REQUEST FOR INFORMATION **DATE:** September 27, 2016 **NO.:** RFI-301

Project Name: 15051-Webster University Interdisciplinary Science Building Project No.: 15051

Subject: Enlarging opening in beam for fire protection

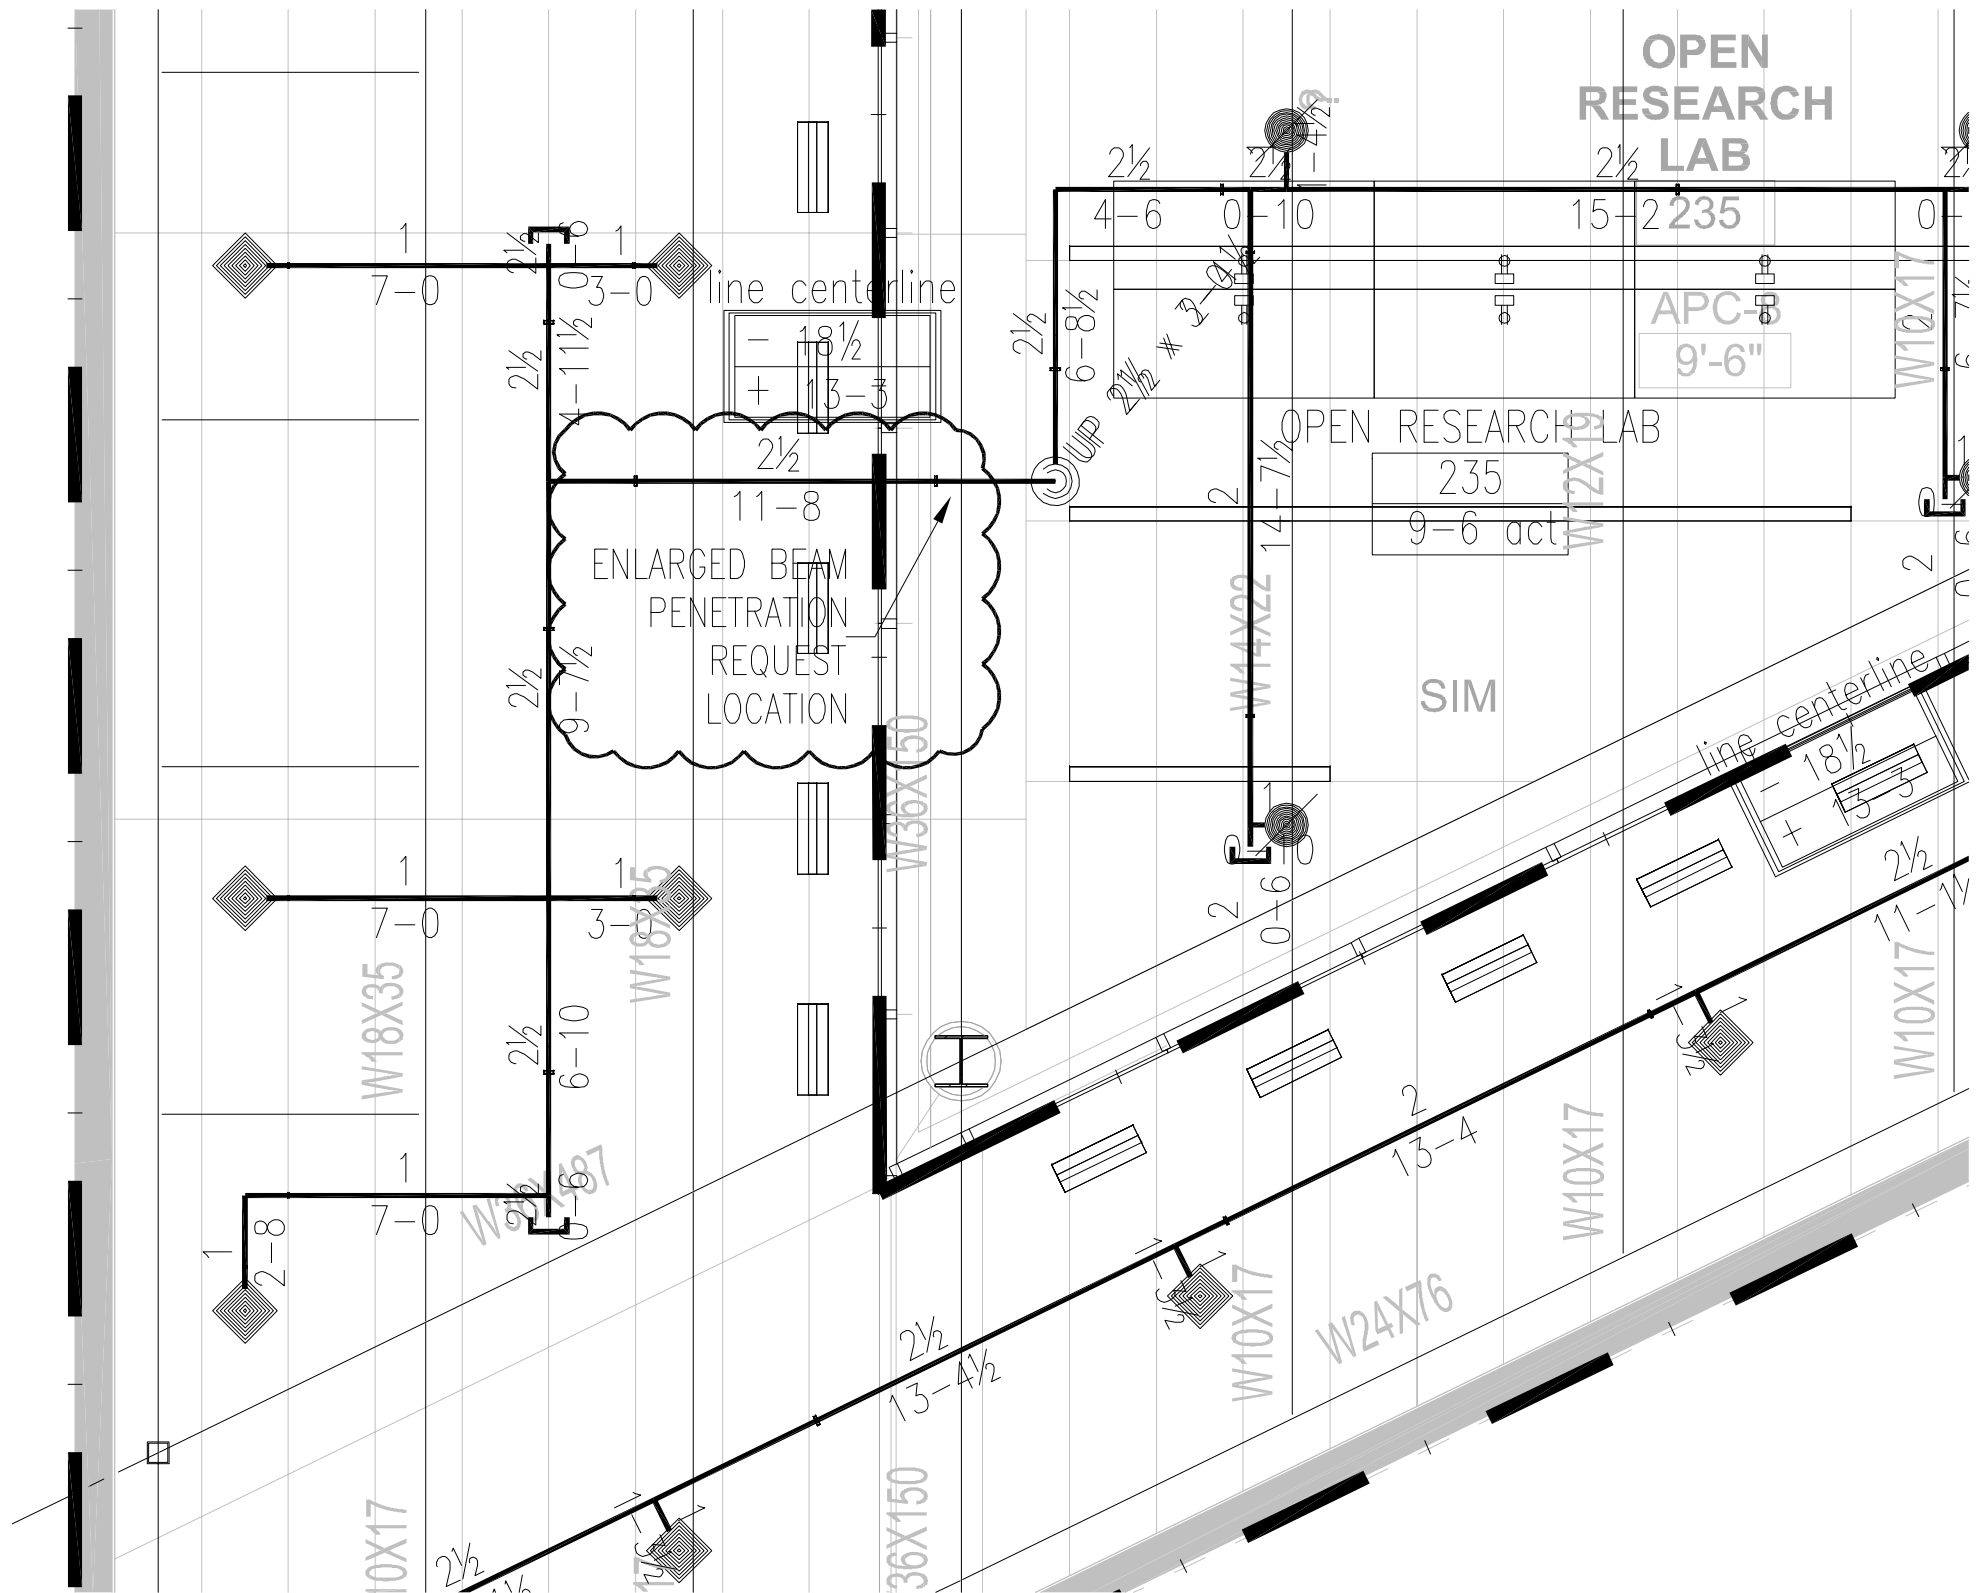
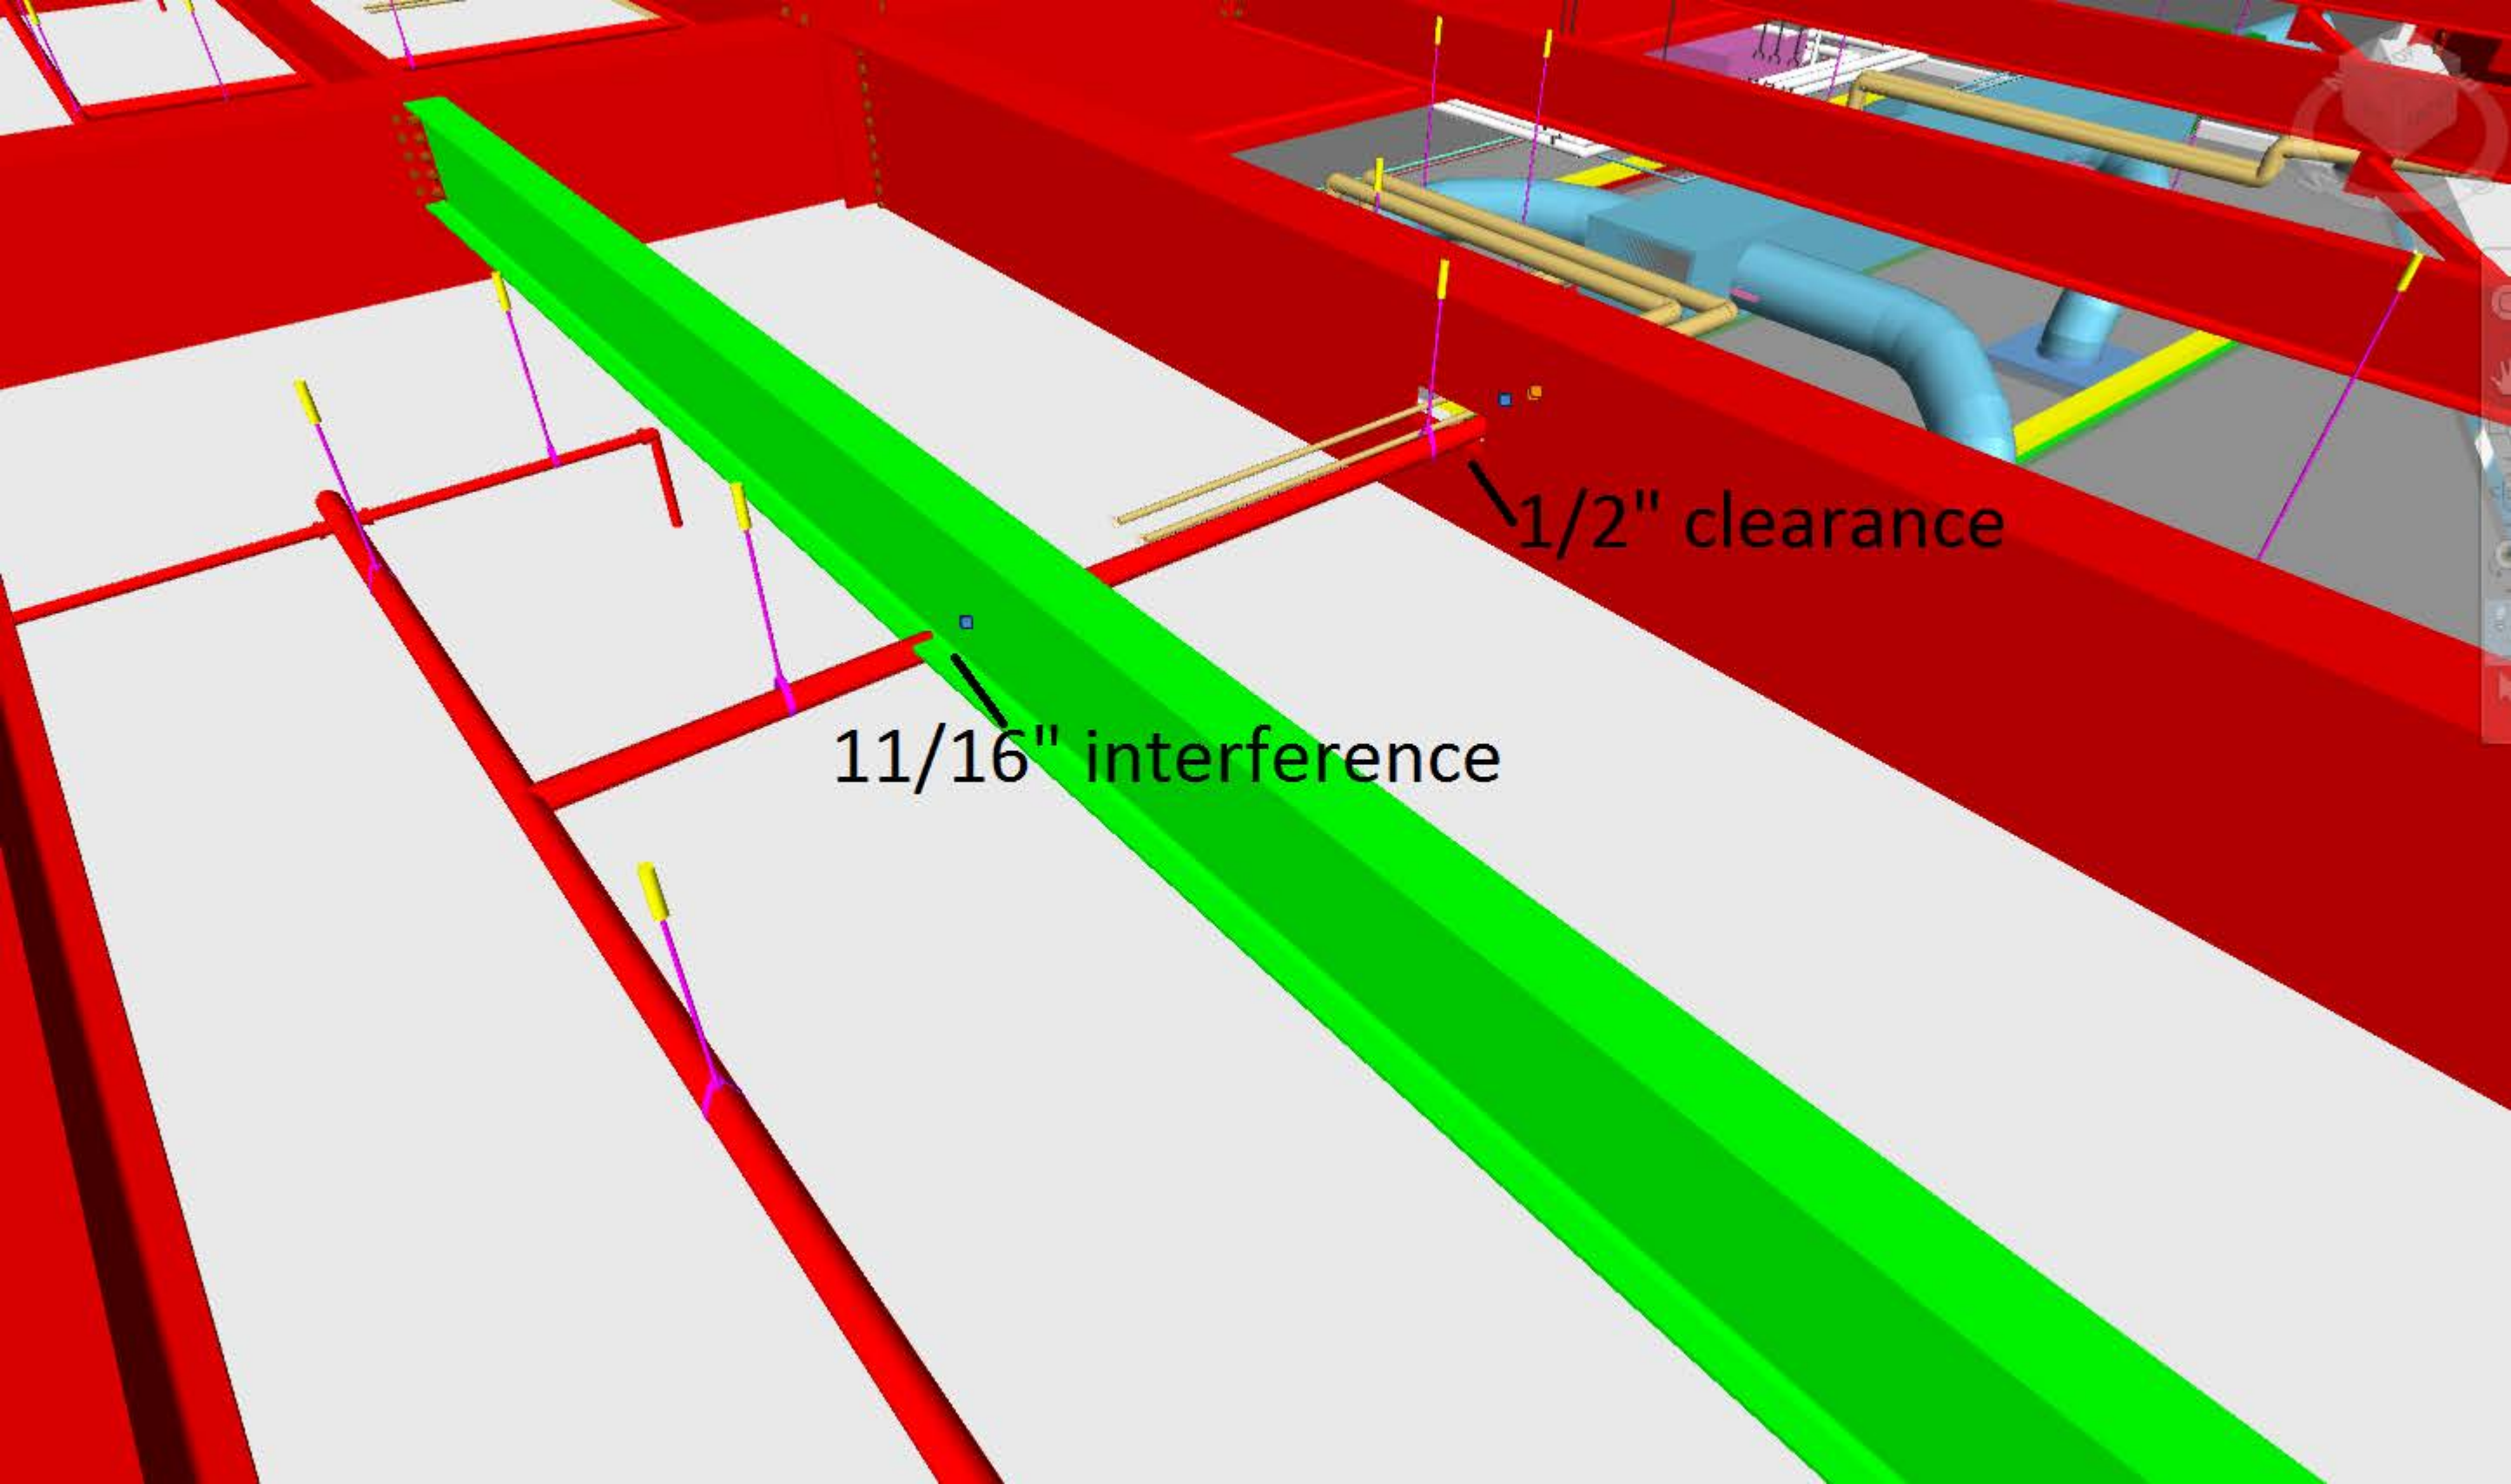
We are having an elevation issue coming through the beam penetrations to feed the dry pendent heads on the external canopy. The existing hole is not deep enough to allow us to get under the W18 beams with the supply piping. (see attached sketches)

Currently there is approximately ½" clearance coming through the existing penetration however there is an 11/16" interference with the W18. Would it be possible to enlarge the hole 1" in depth to allow for the clearance needed to maintain the piping level?

The alternate solution is to add an access panel and route below the beam.

11/16" interference

1/2" clearance

Prior to creating additional or making larger openings in the structural members, the contractor should investigate all piping alternatives and options. The pipe size indicated of 2.5 inches seems to be large for five sprinkler heads. If the size is correct however, the 2.5 inch pipe could be moved to the east of the W18, and multiple smaller diameter piping extended to the heads. This space is also served with a hot water/fin tube heating system for the sprinkler piping. The pipe openings through the steel is to be shared. Layout and installation of the sprinkler piping is to be coordinated with the mechanical contractor as well as all trades. If there are no other alternatives or options available, and additional opening or larger openings are required, the structural shall be consulted.
